**ADDENDUM NO. 1  
INVITATION FOR BID  
RATON FILTER PLANT IMPROVEMENTS**

**Date:** September 18, 2018

**Contracting Agency:** Raton Water Works  
224 Savage Avenue  
Raton, New Mexico 87740  
(575) 445-3861

Solicitors are instructed to incorporate the following clarifications/revisions into their bid for the above referenced Invitation for Bid. Answers to bidder questions are denoted below by **Q** and **A**.

**CHLORINE SYSTEM &  
 CHLORINE DIOXIDE PLANS**

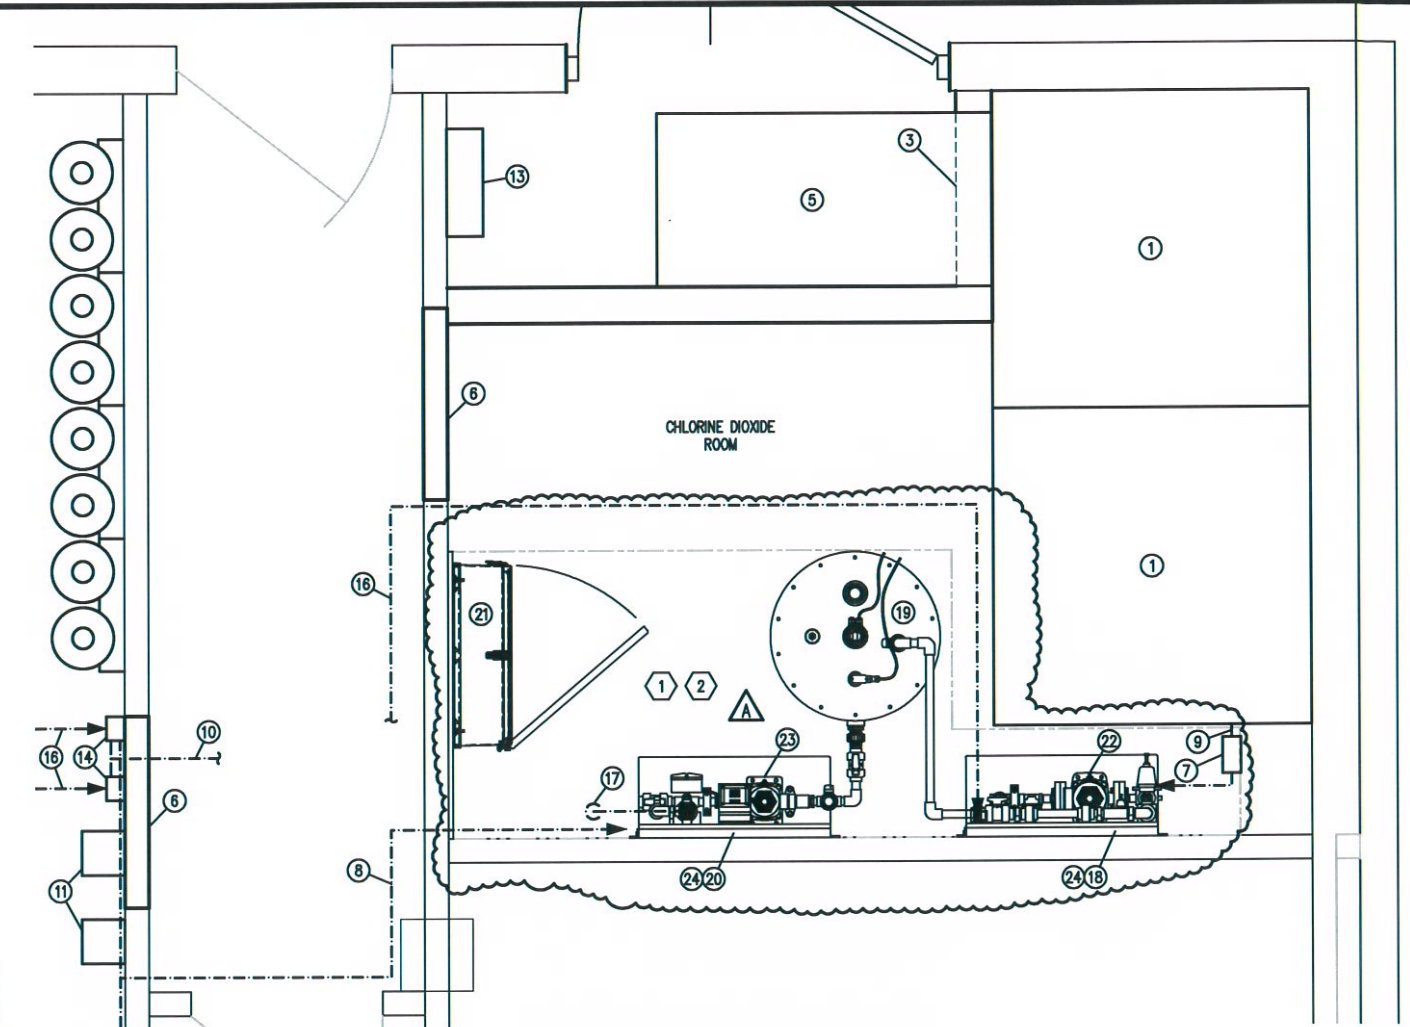
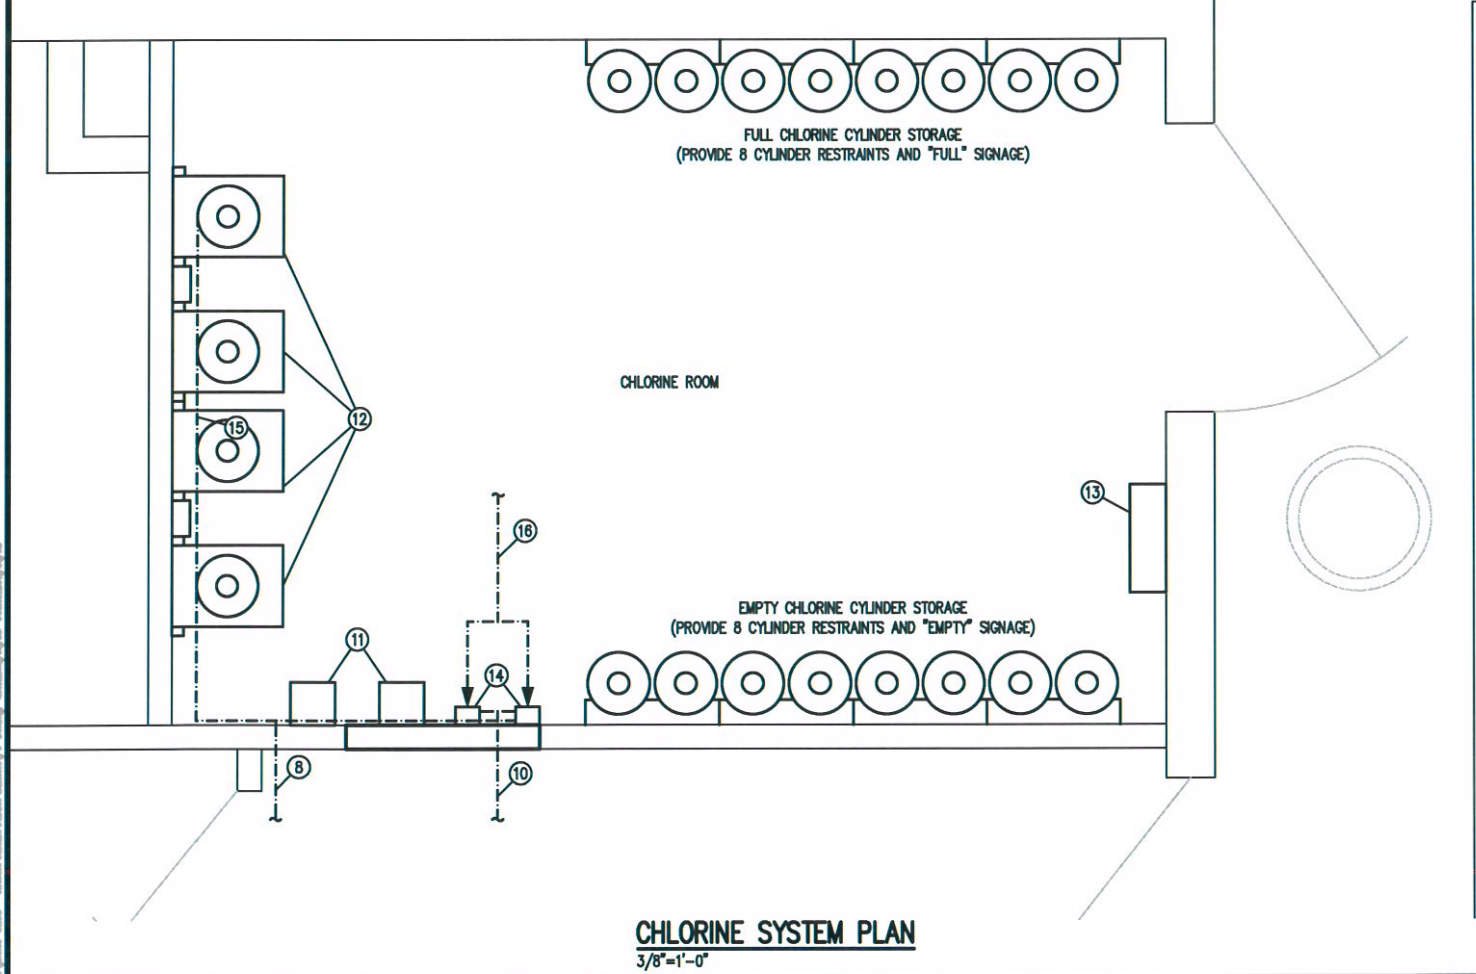
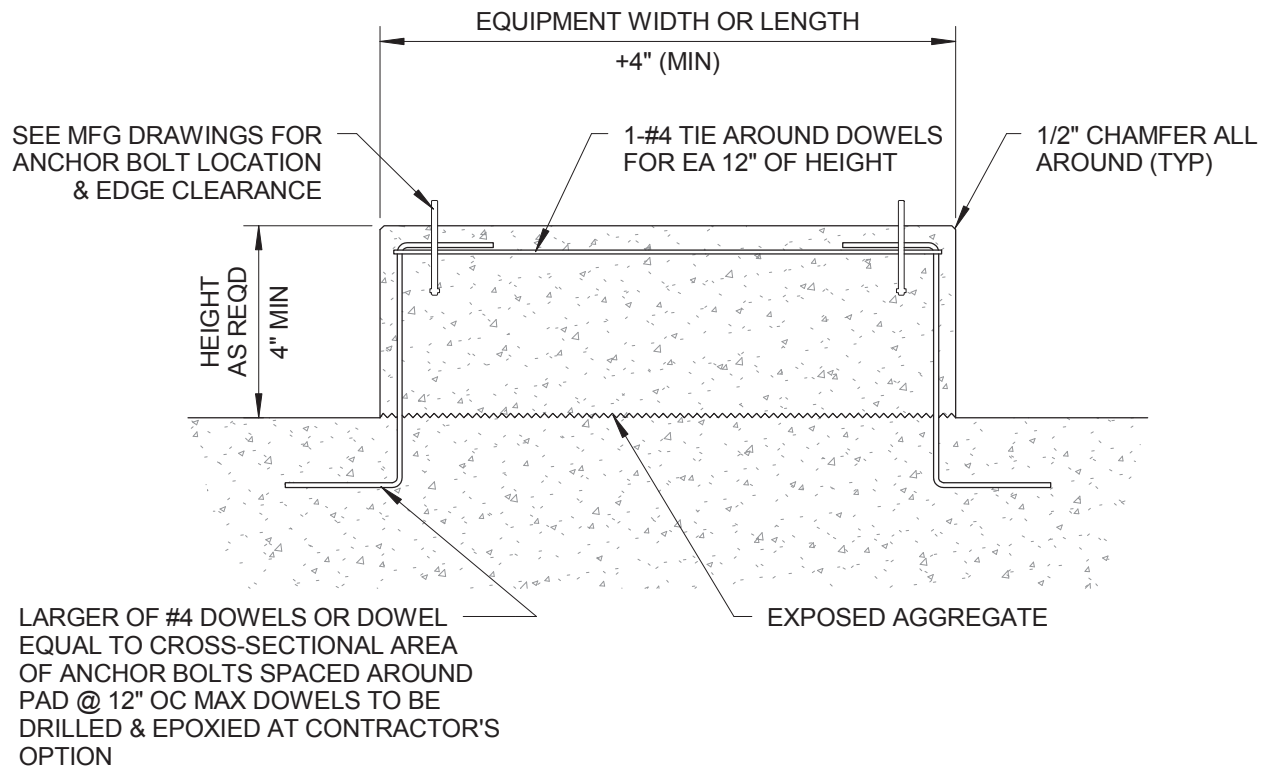
- ① ULTRATECH ULTRA-SPILL PALLET P4 OR EQUAL
- ② NOT USED
- ③ 6" WIDE x 6" HIGH CONTAINMENT CURB
- ④ NOT USED
- ⑤ ULTRATECH ULTRA-SPILL PALLET MOVEABLE RAMP OR EQUAL

- ⑥ REPLACE DOOR W/ CMU AND SHATTER-RESISTANT VIEWING WINDOW CENTERED AT A HEIGHT OF 5' AND 24" SQUARE
- ⑦ SODIUM CHLORITE FILTER (GRANGER MODEL 2P802 HOUSING W/ 2P809 STRAINER. NO SUBSTITUTIONS)

Revision	Date	Description
A	9/11/2018	Bld Phase Addendum No. 1

## EQUIPMENT PAD DETAIL

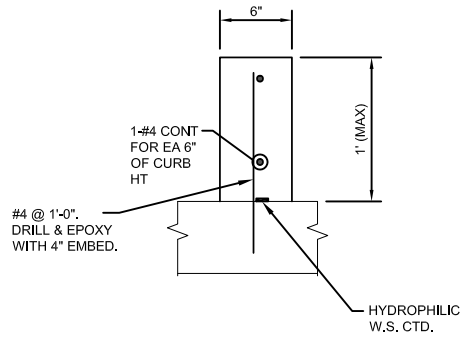
No.	Bid Document	Page	Section	Clarification / Revision
47	Drawing	P3-02	N/A	<p><b>Q:</b> Are concrete pads required under new blowers, or any other equipment or tanks? If so, please provide details.</p> <p><b>A:</b> Please see P3-02: Equipment pads are not required for the blowers. Equipment pads are required for the coagulant tanks (see attached drawing).</p>
48	Specifications	Static Mixers	11302	Add Westfall as an approved static mixer supplier.
49	Specifications	1	16750	On page 1 of Section 16750, add to section 2.1 Manufacturers – Add the following: “5. Robbins Lightning, Inc.”
50	Bid Form	3	Lump Sum Bid Items	Add Base Bid Lump Sum Work Item No. 2A for Extension of Overflow Lines
51	Specifications	1	01270	<p>Delete from 1.2.B.1: “, and replacement of the 24” outlet pipe and slope repair at the water reclamation basin”.</p> <p>Add following Subsection to 1.2 after 1.2.B:</p> <p>“B1. Section No. 2A – Extension of Overflow Lines</p> <ol style="list-style-type: none"> <li>1. This bid item consists of all Work related to extension of the two (2) 24” overflow pipes and slope repair at the water reclamation basin, including but not limited to clearing and grubbing; temporary/ construction slope stabilization; earthwork; installation of pipe, fittings, manhole, concrete collars, headwall and wingwalls, riprap; backfill and compaction; and seeding.</li> <li>2. Payment will be made on a lump sum basis.”</li> </ol>
